ITEM III-A: DESIGN REVIEW PERMIT – 998 SUNRISE AVENUE – SUNRISE POINTE PAD BUILDING – PL14-0580

The applicant requests approval of a Design Review Permit for a new 5,000-square-foot retail pad building, including a vehicle drive-through.

Figure 1: Proposed Site Plan

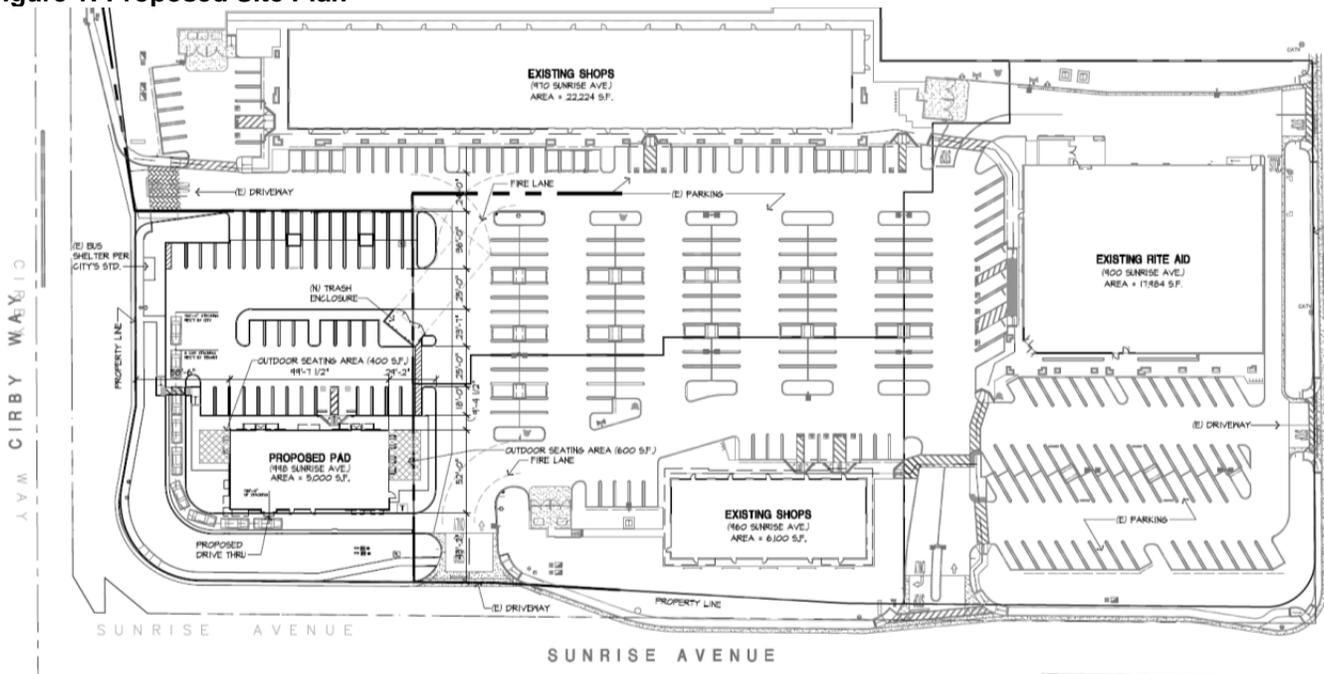
Access and Circulation: The site layout has been designed to provide two (2) access points within the existing parking lot of the Sunrise Pointe Shopping Center. Overall, the Sunrise Pointe Shopping Center has five existing driveway access points, one from Cirby Way to the west, two from Sunrise Ave. to the east and two from Madden Lane to the north. Access to the project site has been designed to ensure there will be no impacts related to vehicular queuing on the adjacent public streets. The drive-through lane includes more than the 180 feet of stacking distance required by Design Guideline CC-30. Staff and the applicant have worked closely on the design of circulation and stacking through the

project site. The resulting design will provide increased throat depth at the Cirby Wy. driveway entrance, while preventing vehicle queuing from affecting the access points to the retail center and adjacent public streets. The proposed circulation plan will not negatively affect public streets or safety. The site access and circulation design has been reviewed by the Engineering Division, Fire Department and Environmental Utilities Department for refuse pick up locations. The site plan and circulation has been found to meet City standards.

Parking: Section 19.26 of the Zoning Ordinance (Off-Street Parking and Loading) requires a restaurant with a drive-through facility to provide 1 parking space for every 50 square feet of building area. The building is 5,000 square feet, of which 1,856 square feet will be dedicated to the drive through restaurant. This will require 37 parking spaces; the remaining 3,144 square feet of convenience restaurant space will require 31 spaces (1 space per 100 sq. ft. of building area). The applicant has provided 52 spaces on-site. The Sunrise Pointe center has a reciprocal parking and access agreement in place to serve the center. Based on the existing uses within the center, there will be ample parking for the restaurant pad building. The site plan shows that there will be an excess of 30 spaces within the retail center.

Based on the Community Design Guidelines policy CC-64, trees should shade at least 50% of the paved parking areas. The parking lot is 13,304 square feet in size, and the trees and shade structures will provide 6,729 square feet of shade, which results in 51% shading. The project meets the shade requirements.
